TECHNICAL BULLETIN

505-18-10

MODEL AFFECTED: 505

SUBJECT: DOOR LOCK RETROFIT KIT

Figure 2 – Workaid

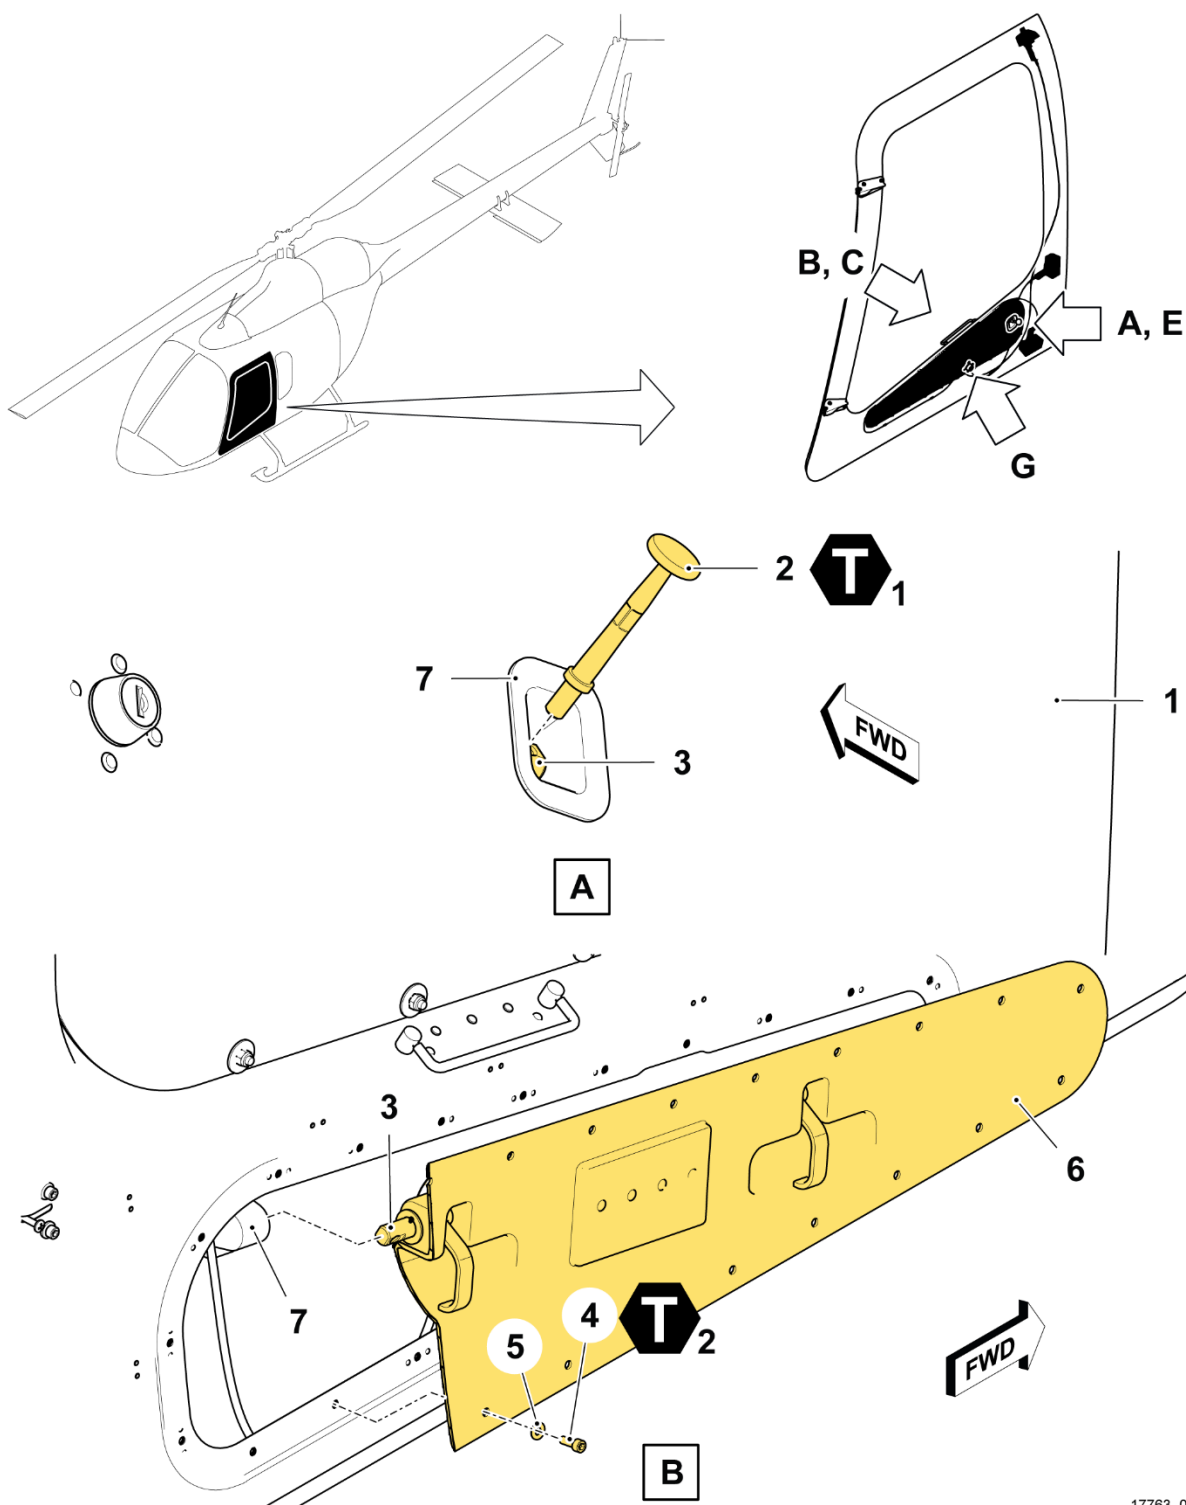
The crew door exterior handle may be difficult to remove due to the Loctite (C-320) requirement during installation. The workaid shown in Figure 2 is recommended to facilitate the removal.

FIGURE 1 – Crew door lock retrofit (Sheet 1 of 10)

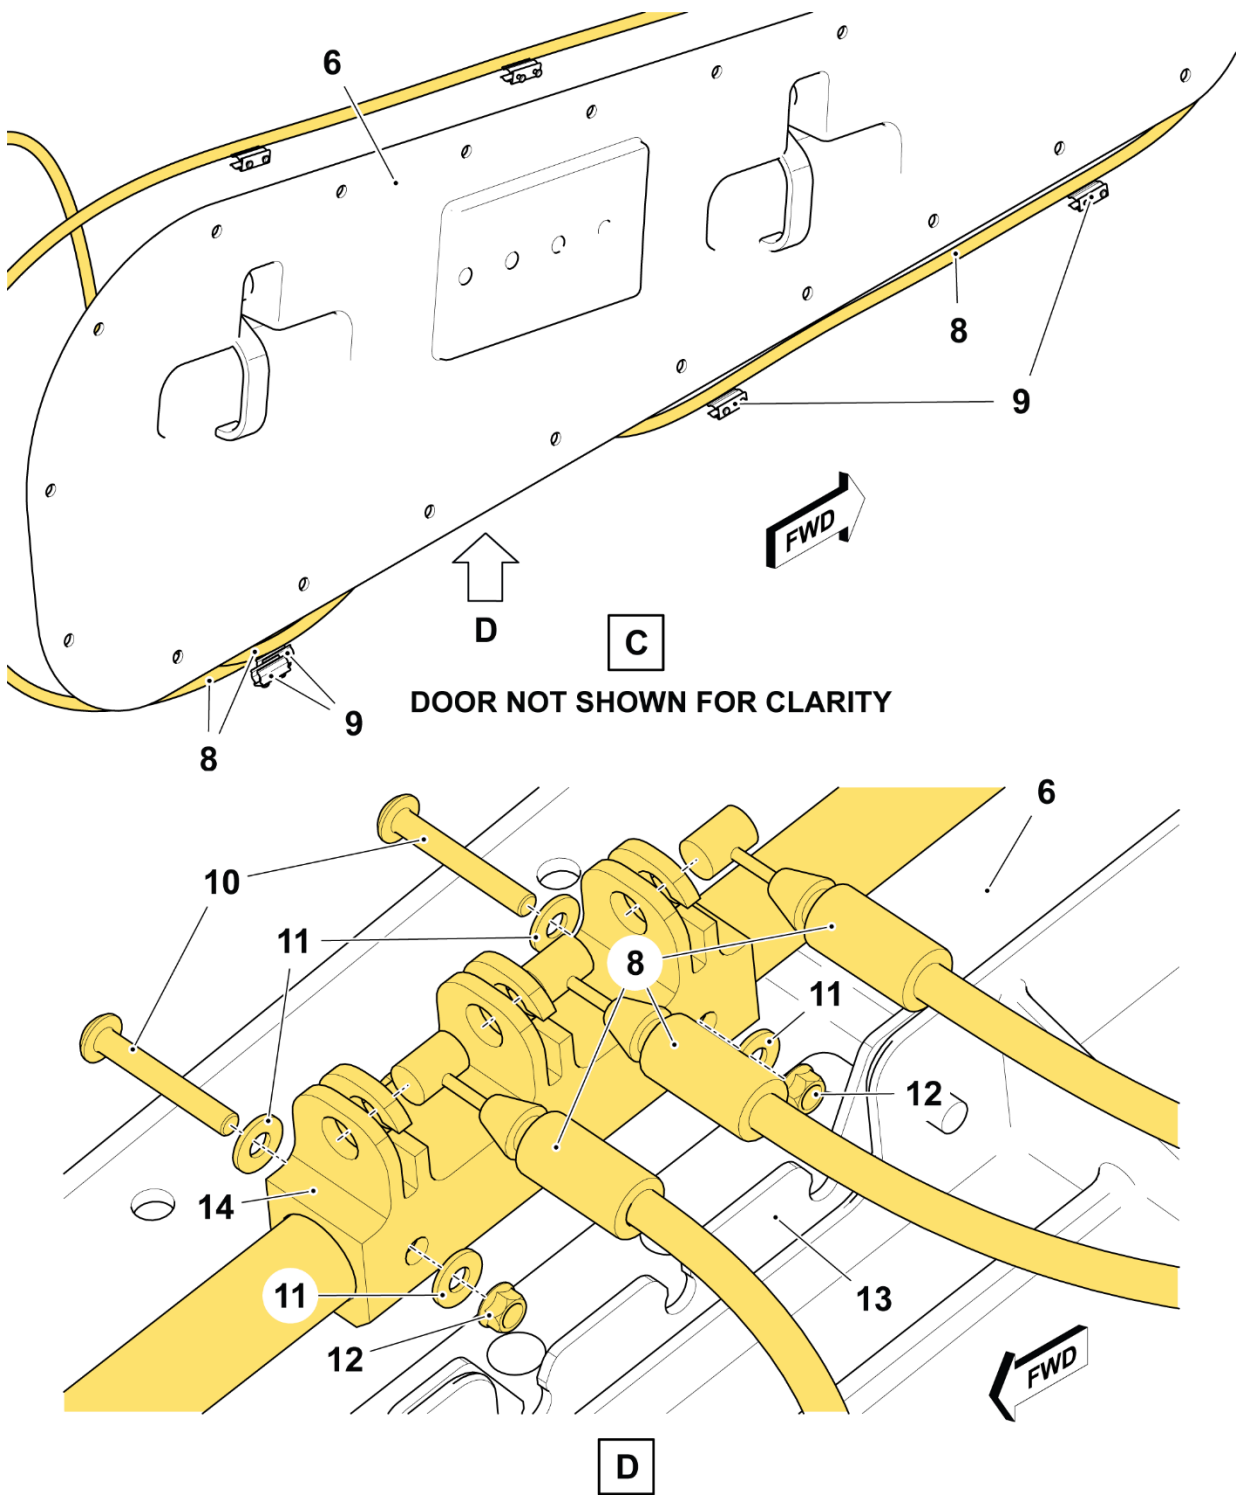
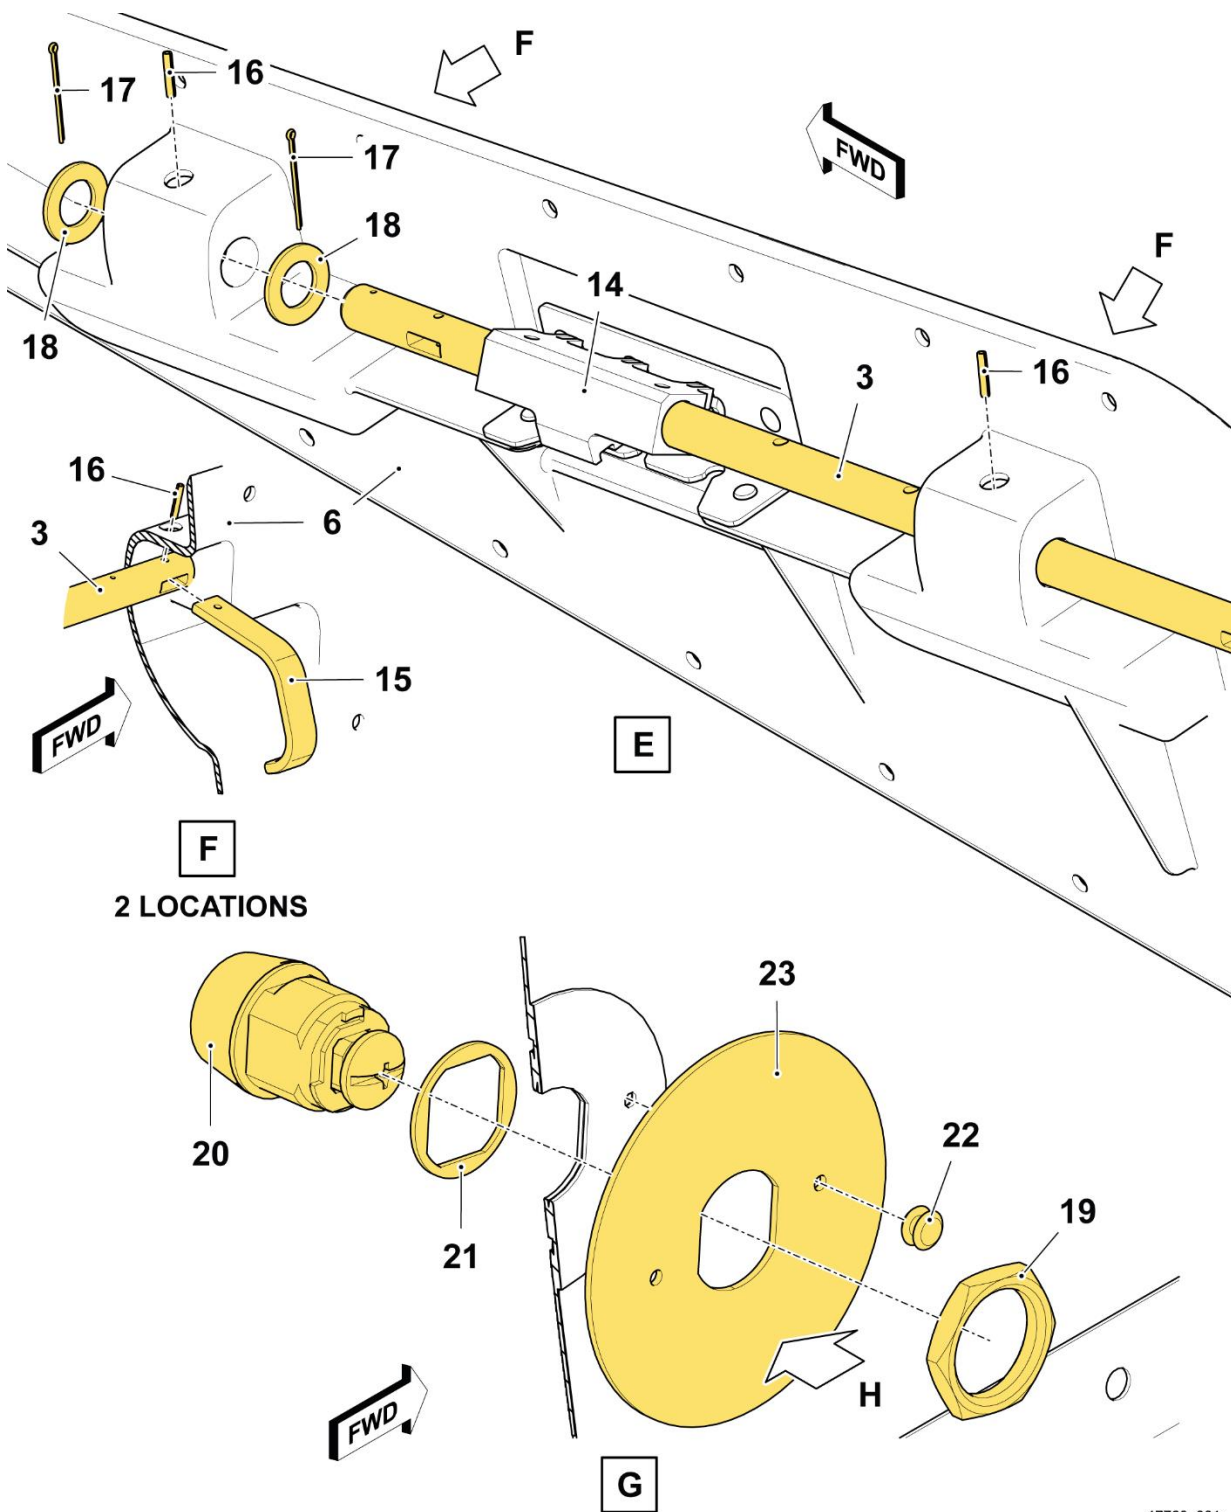
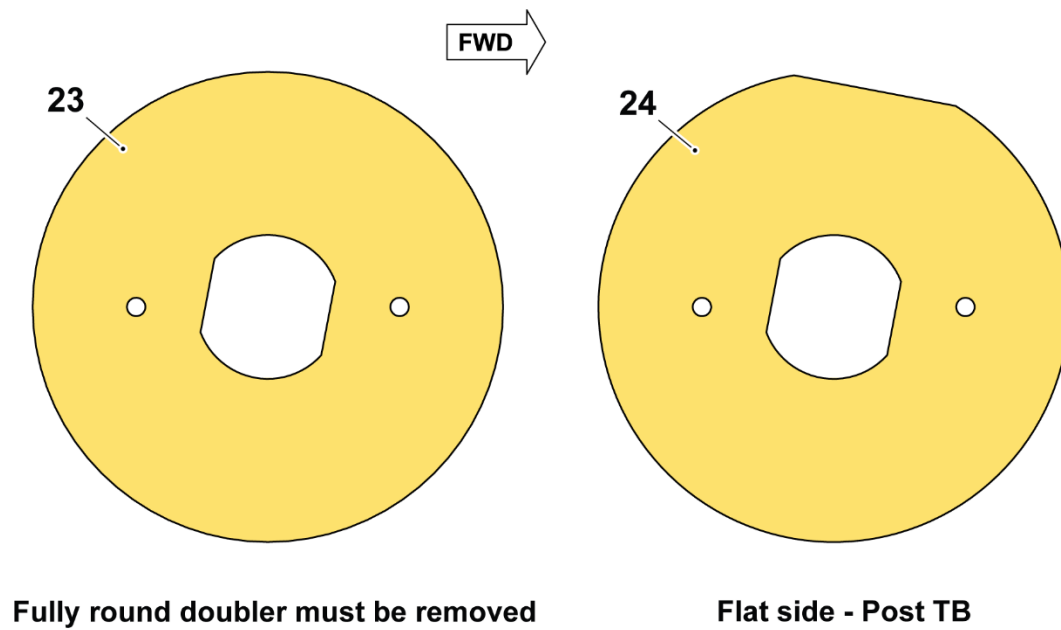
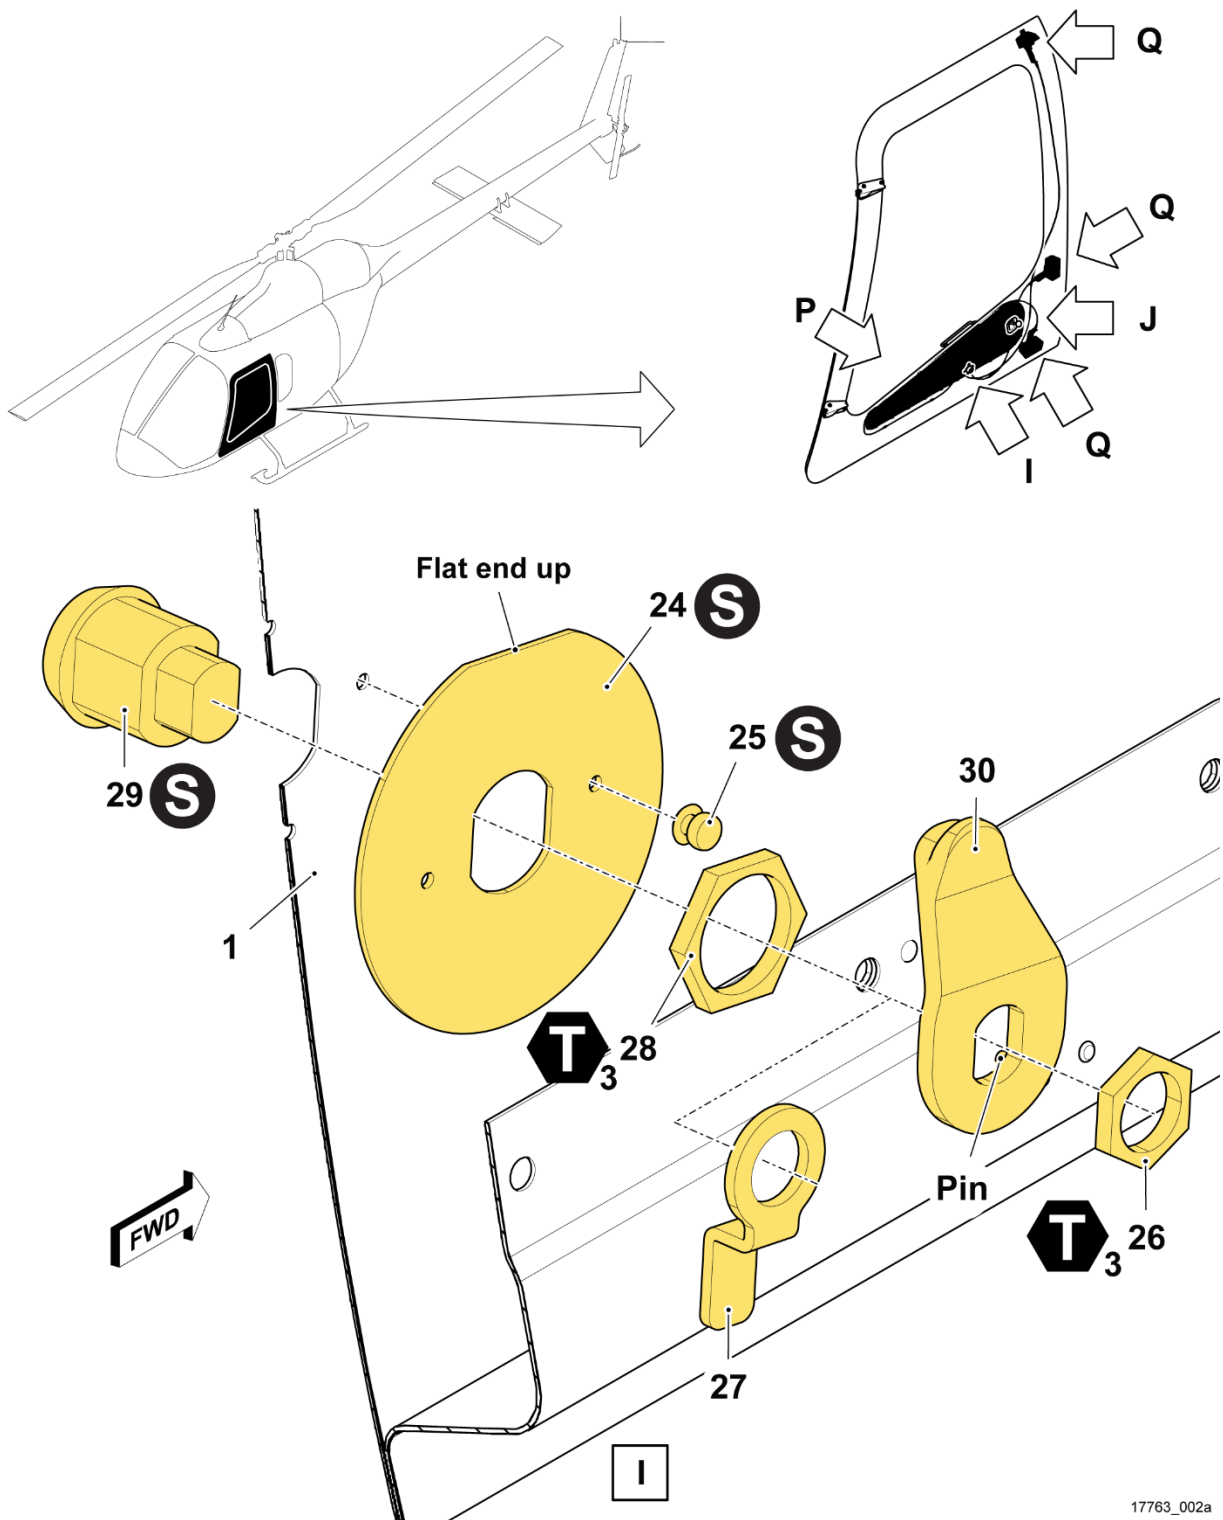
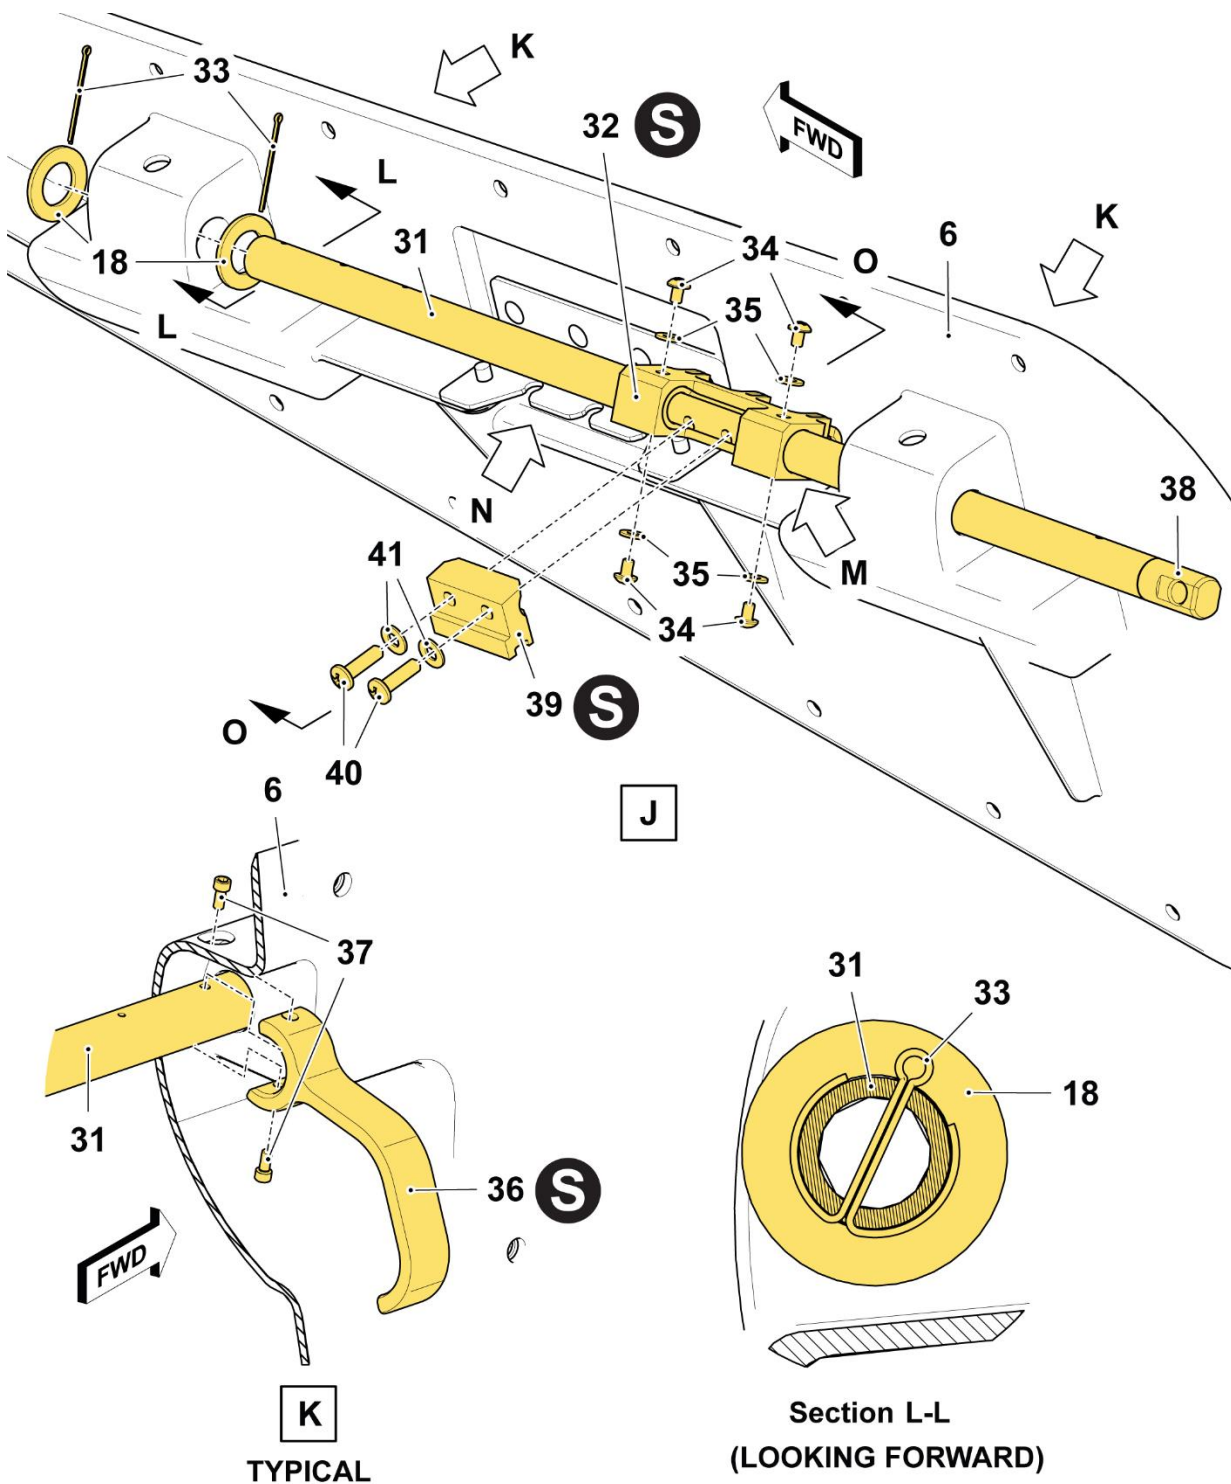
This Technical Bulletin provides instructions to retrofit cabin doors SLS-030-110-001/-002 with latest production door locks. The change offers a door opening mechanism that can be opened from the inside when locked. Applicability of this bulletin to any spare part shall be determined prior to its installation on an affected helicopter.

- a. If the currently installed doubler resembles item 23 in detail H, proceed to step 15.
- b. If the currently installed doubler resembles item 24 which has a flat portion on the top, disregard steps 15 to 18 and continue from step 19 onward.

The doubler (24) SLS-030-110-267 is to be installed with the flat section facing up.

Opening on the lock assembly (29) for the pin on the cam (30) must be on the bottom when installed.

The end of the outer actuator rod (31, View J) which has cotter pin holes must be directed FWD when installed on the inner door panel (6).

The cable insertion hole of the actuator fitting (32, View N) must be directed inboard when installed.

The door lock mechanism is designed to induce a positive pressure from the cam (30, Section O-O) onto the lock fitting (39) when placed in the locked position to prevent movement of the exterior handle (2, View A).

- a. Verify each latch bolt (42, Section R-R) recesses 0.080 to 0.100 inch (2.03 to 2.54 mm) inside the latch housing (43) by operating interior handle (36, View P) and exterior handle (2, View A) individually to their full unlatched position.
